CALL NO. 101
CONTRACT ID NO. 221035
ADDENDUM # 2

Subject: FAYETTE COUNTY, NHPP 0754 (065)
Letting August 18, 2022

(1) Added - Proposal Sheet - Page 49(a) of 197

REPLACE OSS COL. ASSEMBLY

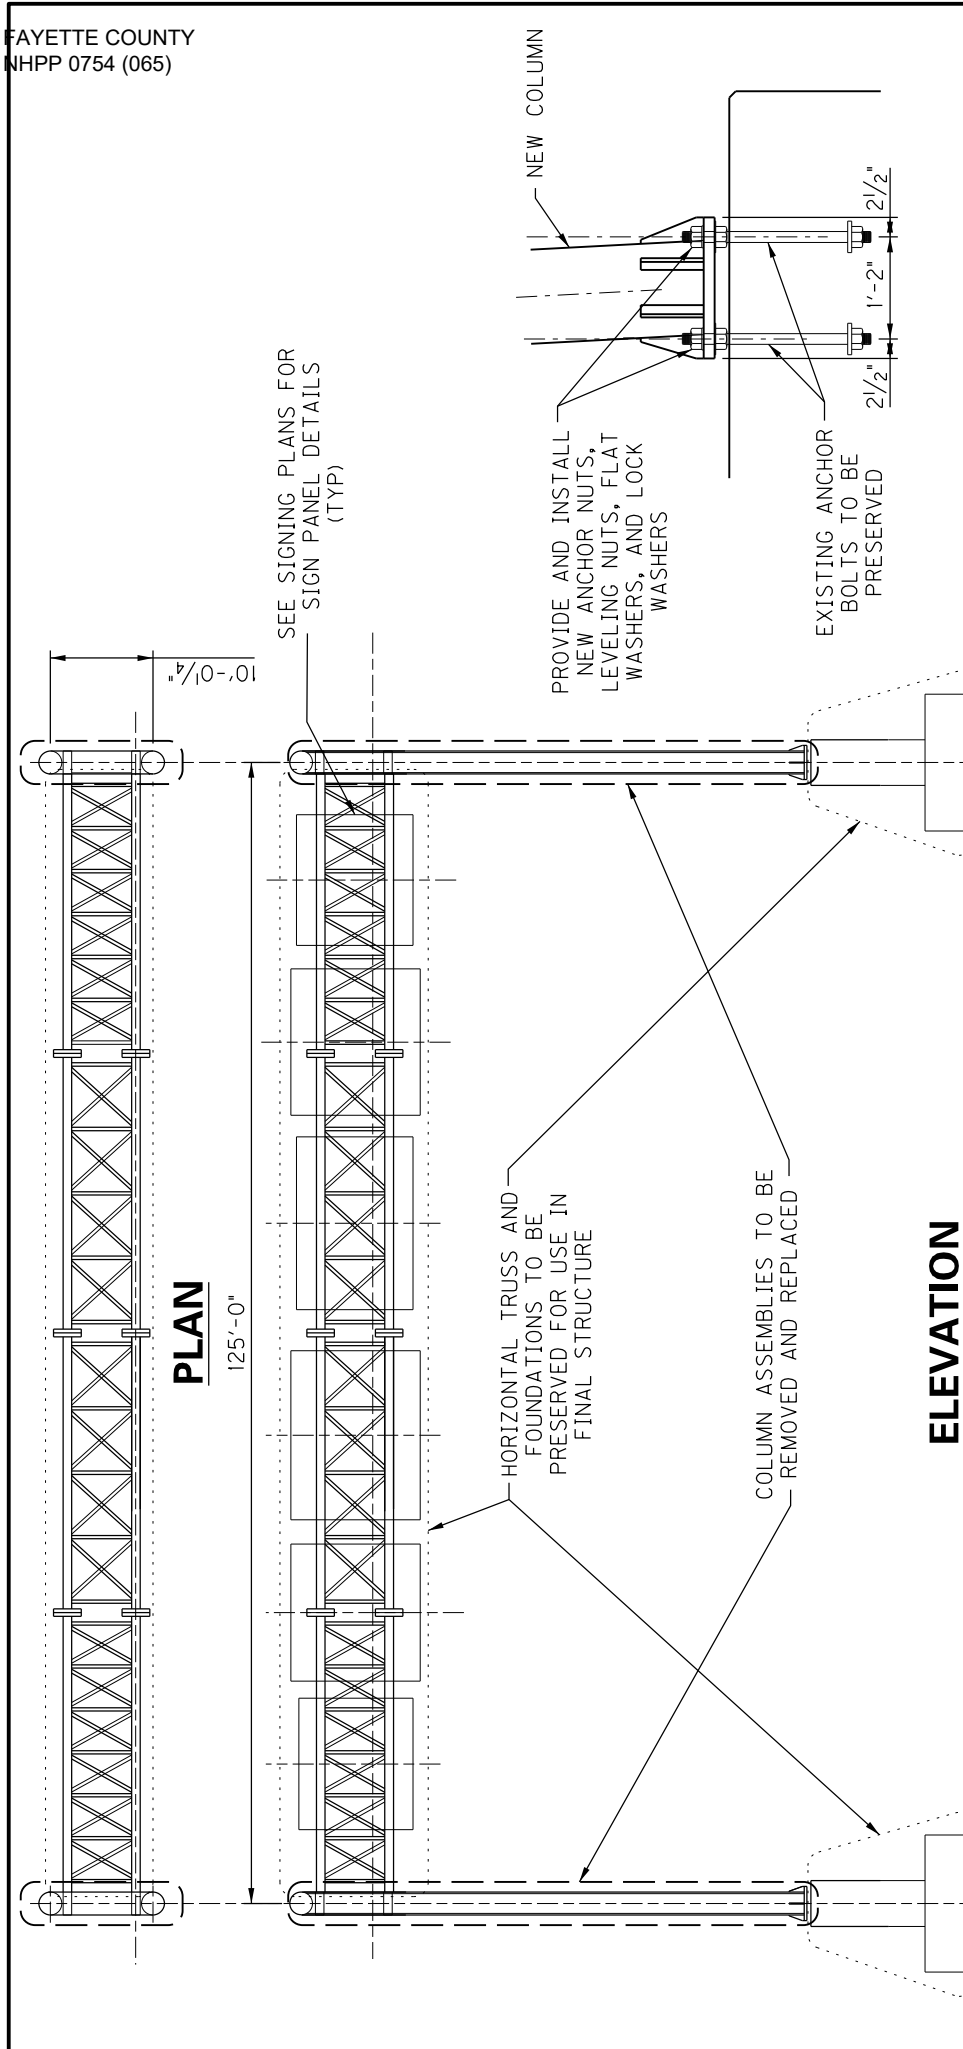
REMOVE AND REPLACE BOTH COLUMN ASSEMBLIES. HORIZONTAL TRUSS AND FOUNDATIONS WITH ANCHOR BOLTS SHALL BE PRESERVED AND REINSTALLED WITH NEW COLUMN ASSEMBLIES FABRICATED IN ACCORDANCE WITH THE KYTC STANDARD DRAWING 110'-140' OVERHEAD SIGN SUPPORT. THE COMPLETED STRUCTURE SHALL MEET ALL CLEARANCE LIMITS SHOWN IN THE STANDARD DRAWING. CONTRACTOR SHALL VERIFY ALL DIMENSIONS PRIOR TO ORDERING MATERIALS. WHEN FIELD MEASURED DIMENSIONS DIFFER FROM THE STANDARD DRAWING CONTACT THE ENGINEER. CONTRACTOR TO PROVIDE NEW COLUMN ASSEMBLIES, ANCHOR NUTS, LEVELING NUTS, FLAT WASHERS, LOCK WASHERS, U-BOLTS, SHIM PLATES, BENT PLATES, NUTS, WASHERS AND ANY OTHER ITEM NECESSARY TO CONNECT THE NEW COLUMN ASSEMBLIES TO THE PRESERVED FOUNDATION AND HORIZONTAL TRUSS. REFER TO KYTC STANDARD DRAWING 110'-140' OVERHEAD SIGN SUPPORT FOR DETAILS. ANY MATERIALS REMOVED BECOME THE PROPERTY OF THE CONTRACTOR. A ROADWAY CROSS SECTION SHALL BE PERFORMED FOR THIS STRUCTURE IN ACCORDANCE WITH THE STANDARD DRAWING. PAYMENT FOR ALL LABOR, MATERIALS, EQUIPMENT AND ANYTHING ELSE REQUIRED TO COMPLETE THE ROADWAY CROSS SECTION AND WORK SHOWN HERE IS INCIDENTAL TO THE UNIT PRICE BID FOR "ROADWAY CROSS SECTION".
